**SERVICE BULLETIN**

**N° 189-316**

**ATA 93 - FLIR 380 HDC REMOVABLE PARTS INSTALLATION**

This Service Bulletin is issued in order to provide the necessary instruction on how to complete the installation of Kit FLIR 380 HDc P/N 8G9350F00611.

**Figure 1**

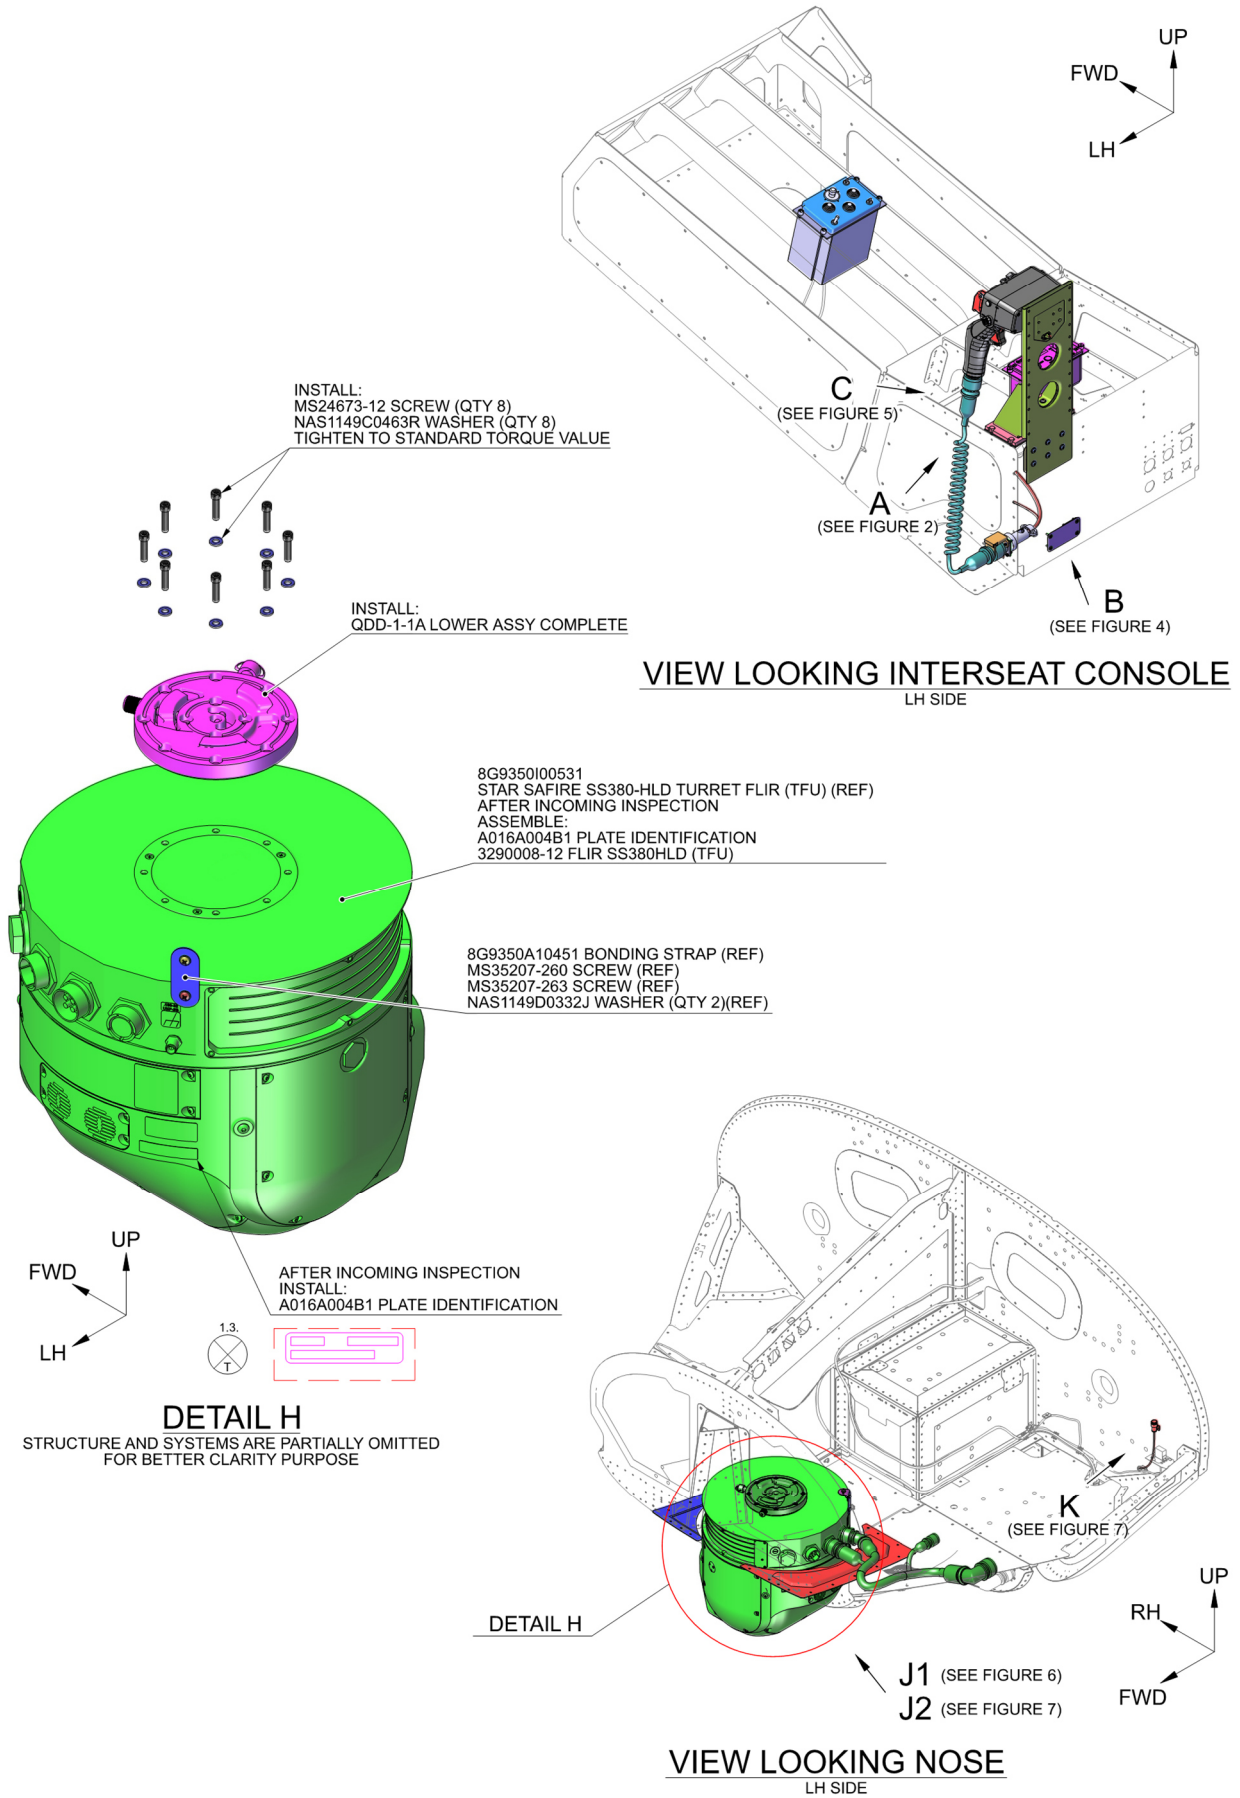
- 6.3 With reference to Figures 1 and 6, perform the FLIR SS 380 HDC removable parts P/N 8G9350A12911 as described in the following procedure:
  - 6.3.1 With reference to Figure 1 Detail H, assemble the Star Safire SS380-HDC turret FLIR (TFU) (A124) P/N 8G9350I00531: install the plate identification P/N A016A004B1 in the indicated position on the FLIR SS380HDC (TFU) P/N 3290008-12.

- 6.3.2 With reference to Figure 1 Detail H, install the lower assy complete P/N QDD-1-1A on the Star Safire SS380-HDC turret FLIR (TFU) P/N 8G9350I00531 by means of n°8 screws P/N MS24673-12 and n°8 washers P/N NAS1149C0463R.

- 6.3.3 In accordance with AMP DM 89-A-20-00-00-00A-711A-A and with reference to Figure 1 Detail H, tighten the eight screws to the standard torque value with an applicable torque wrench.

- 6.3.4 With reference to Figure 1 Detail H and Figure 6 View J1, carefully lift and install the lower assy complete P/N QDD-1-1A and the Star Safire SS380-HDC turret FLIR (TFU) (A124) P/N 8G9350I00531 on the upper bracket P/N QDD-10. Slowly turn the turret unit until the lower assy complete engages its interface on the structure fully. Install the safety pin to lock the position and tighten the locking bolt to prevent unwanted movement of the turret unit.
- 6.3.5 With reference to Figure 1 Detail H and Figure 6 View M, install the bonding strap P/N 8G9350A10451 and fix one end to the turret unit end by means of the screw P/N MS35207-260 and n°2 washers P/N NAS1149D0332J and the other end to the bracket assy

**Figure 2**

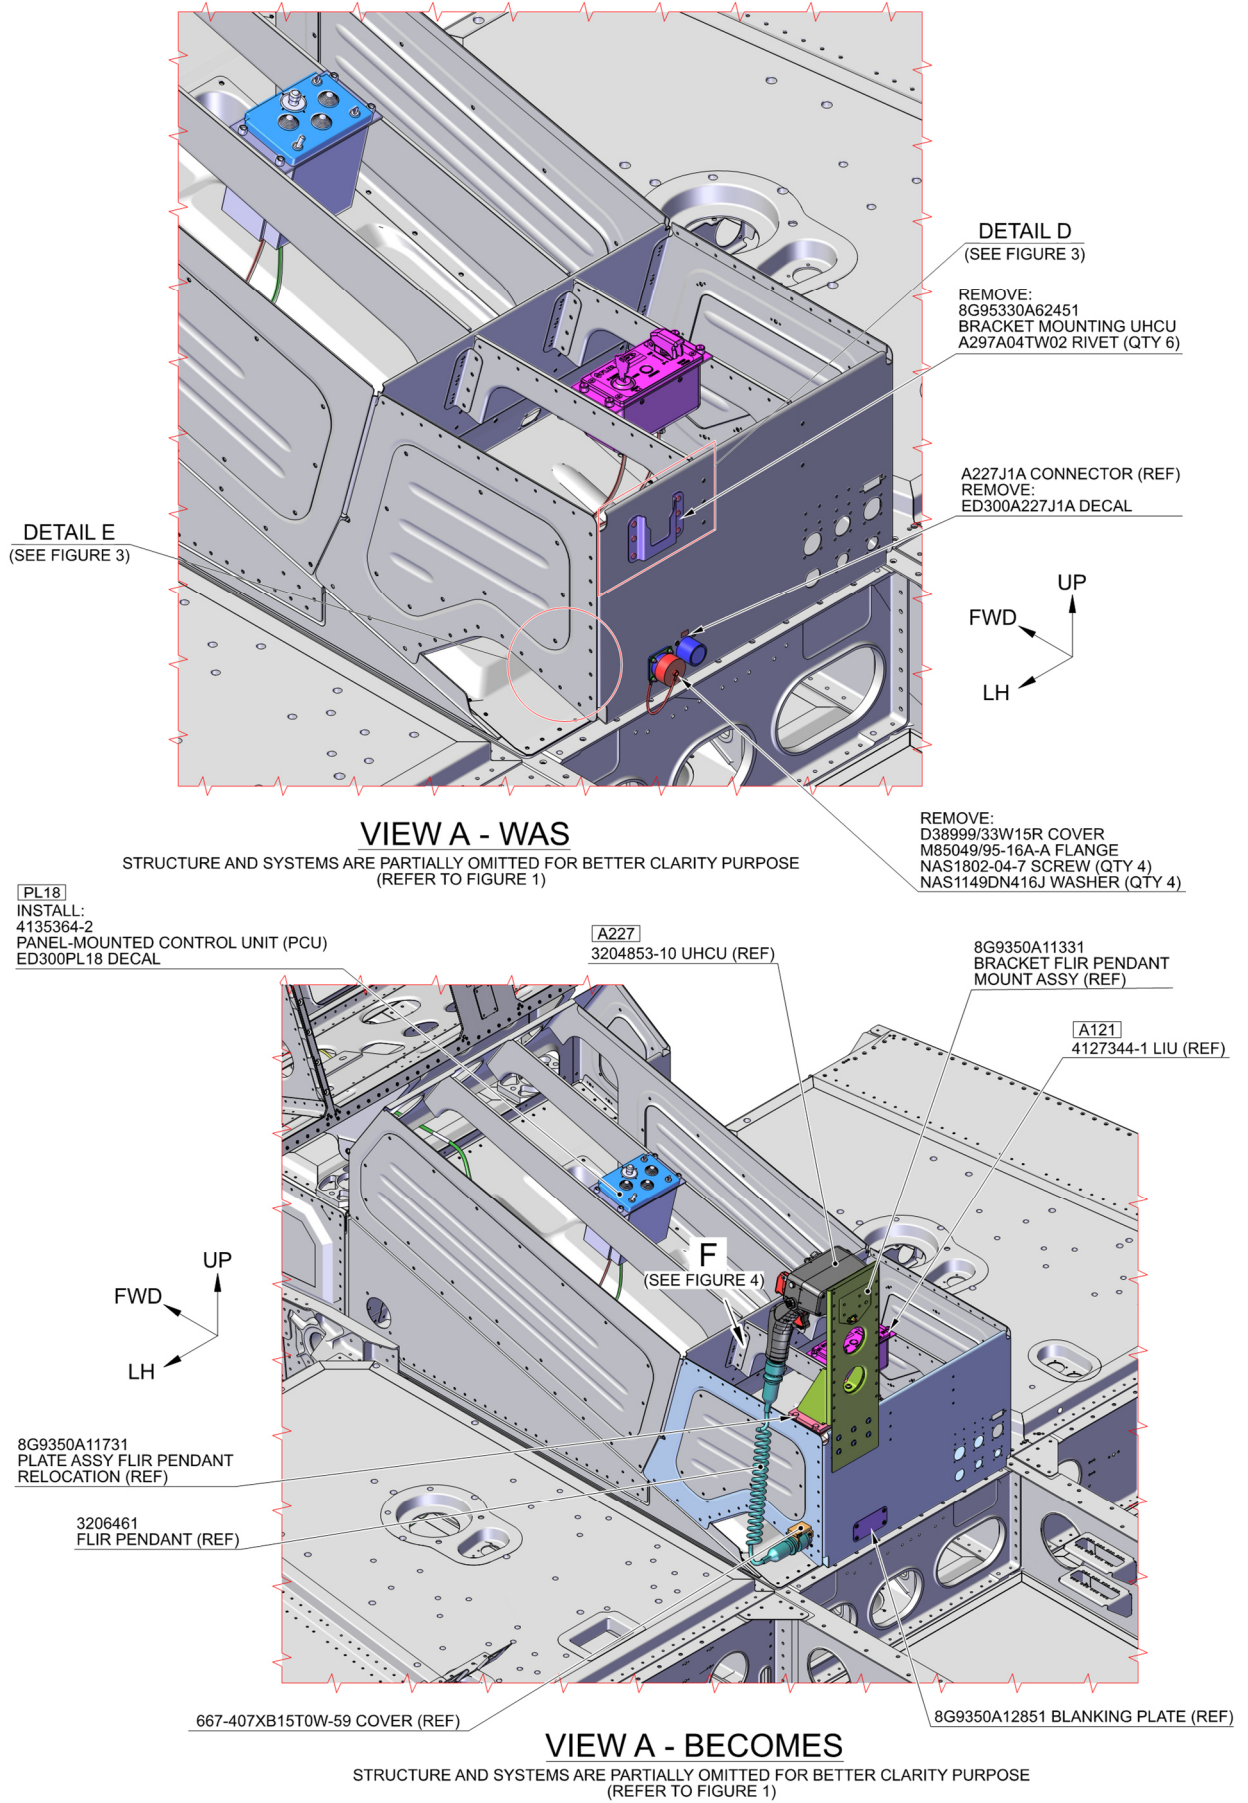
- 5.1 With reference to Figure 2 View A “Was”, remove the decal P/N ED300A227J1A from the interseat console extension near the connector A227J1A.
  - 5.2 With reference to Figure 4 View F, remove and retain for later reuse the flange P/N M85049/95-16A-A, n°4 screws P/N NAS1802-04-7 (retain only two screws) and n°4 washers P/N NAS620-4L from the interseat console extension.

- 5.4 With reference to Figure 2 View A “Was”, remove the cover P/N D38999/33W15R, the flange P/N M85049/95-16A-A, n°4 screws P/N NAS1802-04-7 and n°4 washers P/N NAS1149DN416J from the interseat console extension.

- 5.5 With reference to Figure 2 View A “Was”, remove the bracket mounting UHCU P/N 8G5330A62451 and n°6 rivets P/N A297A04TW02.
  - 5.6 With reference to Figures 3 thru 5, perform pendant relocation struct provs P/N 8G5310A53011 as described in the following procedure:

- 6.2.3 With reference to Figure 2 View A “Becomes”, install the panel-mounted control unit (PCU) (PL18) P/N 4135364-2 in its position on the interseat console by means of its four captive screws. Perform electrical connection of the connector PL18P1 (C/A A2A387 and C/A A1A446) to the PCU (PL18).

- 6.2.4 In accordance with AMP DM 89-A-11-00-01-00A-720A-A and with reference to Figure 2 View A “Becomes”, install the decal P/N ED300PL18 on the structure of the interseat console in an area adjacent PCU (PL18).

**Figure 3**

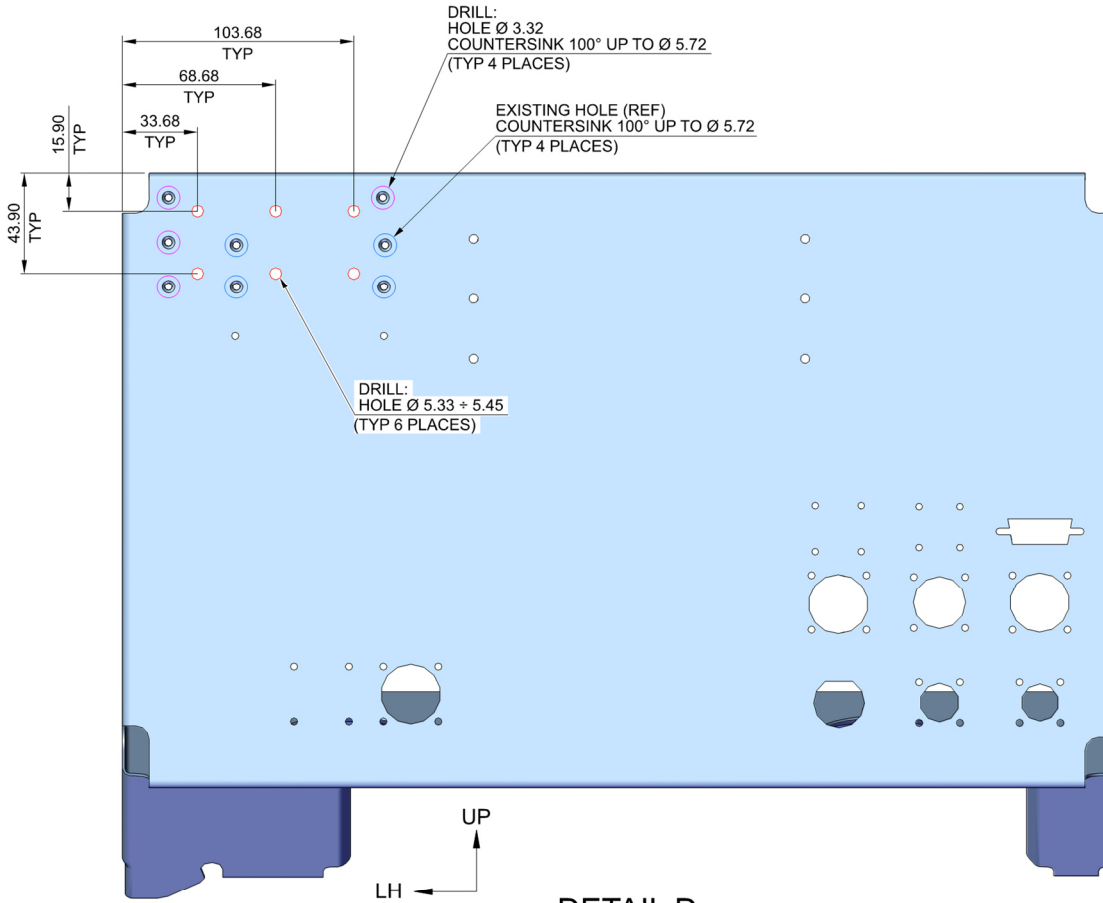
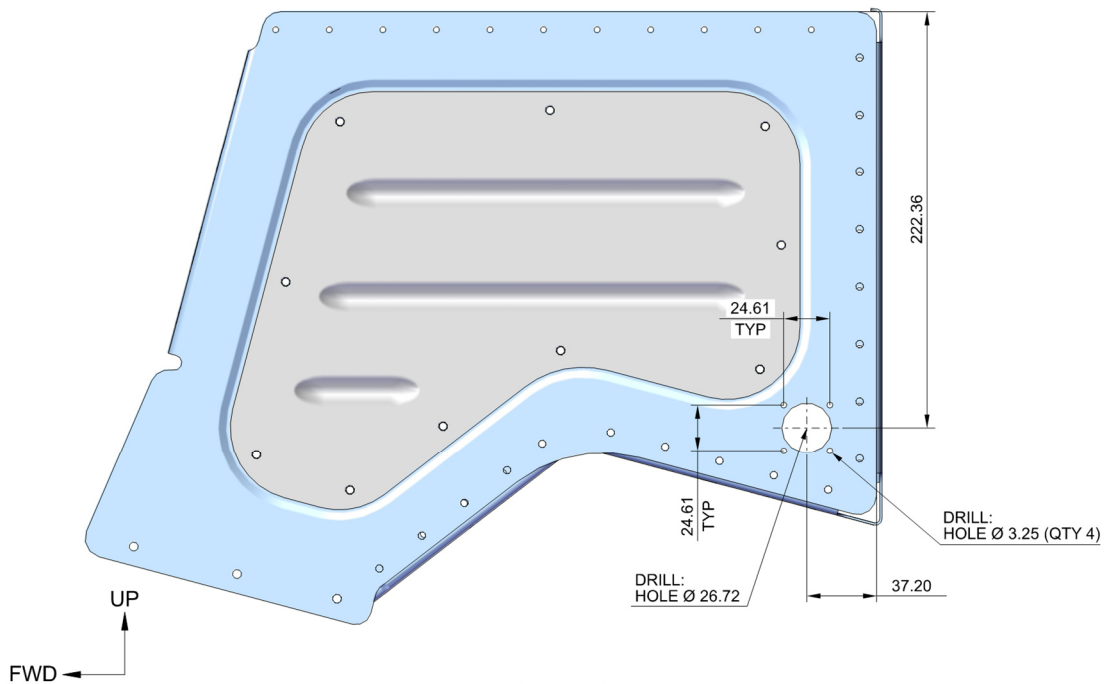
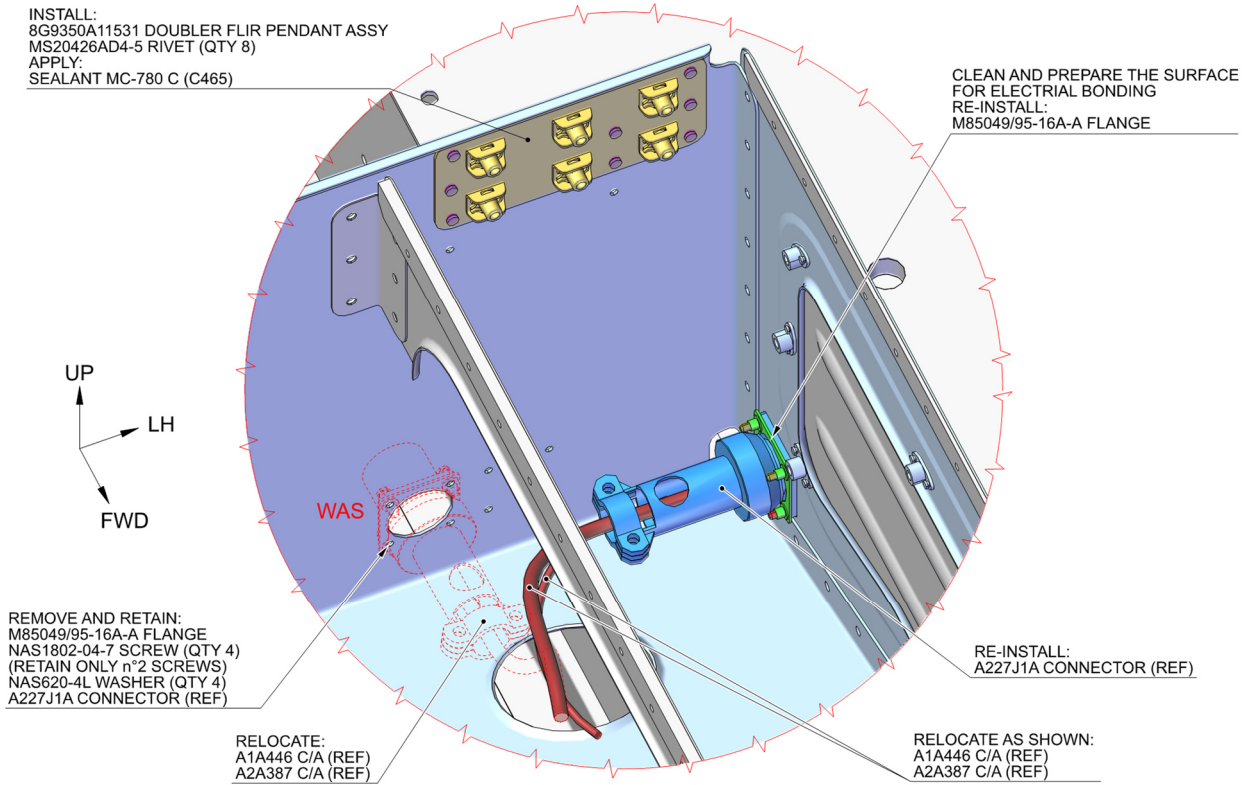
- 5.6.2 With reference to Figure 3 Detail D, drill n°6 holes  $\varnothing 5.33 \pm 5.45$  thru the structure of the interseat console extension in accordance with the dimensions shown.

- 5.6.4 With reference to Figure 3 Detail D, drill n°4 holes  $\varnothing 3.32$  thru the structure of the interseat console extension and countersink 100° holes up to  $\varnothing 5.72$ .

- 5.6.5 With reference to Figure 3 Detail D, countersink 100° n°4 existing holes up to Ø5.72.
- 5.6.6 With reference to Figure 4 View F, install the doubler FLIR pendant assy P/N 8G9350A11531 on the interseat console extension by means of n°8 rivets P/N MS20426AD4-5. Apply sealant MC-780 C (C465).

- 5.7 With reference to Figures 3 thru 5, perform FLIR SS380-HDC U-HCU relocation P/N 8G9350P01011 as described in the following procedure:
  - 5.7.1 With reference to Figure 3 Detail E, drill n°1 hole Ø26.72 and n°4 holes Ø3.25 thru the structure of the interseat console extension in accordance with the dimensions shown.

**Figure 4**

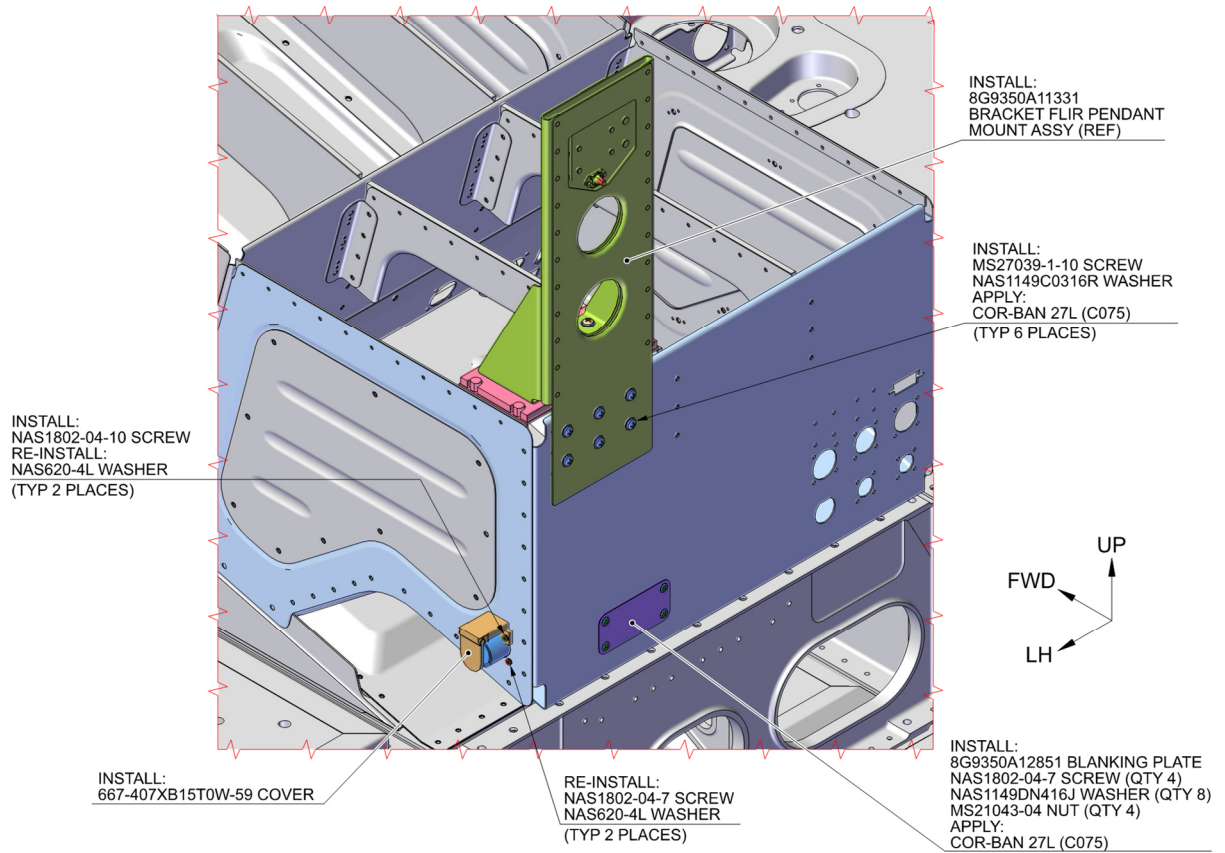
- 5.3 With reference to Figure 4 View F, disconnect the connector A227J1A together with the C/As A1A446 and A2A387 from the structure of the interseat console extension.

- 5.6.1 With reference to Figure 4 View B, install the blanking plate P/N 8G9350A12851 on the interseat console extension by means of n°4 screws P/N NAS1802-04-7, n°4 nuts P/N MS21043-04 and n°8 washers P/N NAS1149DN416J. Apply Cor-Ban 27L (C075).

- 5.6.3 With reference to Figure 4 View F, temporarily locate the doubler FLIR pendant assy P/N 8G9350A11531 in its position on the interseat console extension in accordance with the existing holes.

- 5.6.9 With reference to Figure 4 View B, fix the bracket FLIR pendant mount assy P/N 8G9350A11331 to the doubler FLIR pendant assy P/N 8G9350A11531 and to the interseat console extension by means of n°6 screws P/N MS27039-1-10 and n°6 washers P/N NAS1149C0316R. Apply Cor-Ban 27L (C075).

- 5.7.2 With reference to Figure 4 View F, clean and prepare the contact surface for electrical bonding.
  - 5.7.3 With reference to Figure 4 View F, relocate the connector A227J1A (previously disconnected) and the C/As A1A446 and A2A387 in the new position.

- 5.7.4 With reference to Figure 4 View B and View F, connect the connector A227J1A to the structure and install the flange P/N M85049/95-16A-A (previously removed) and the cover P/N 667-407XB15T0W-59 by means of n°2 screws P/N NAS1802-04-10, n°2 screws
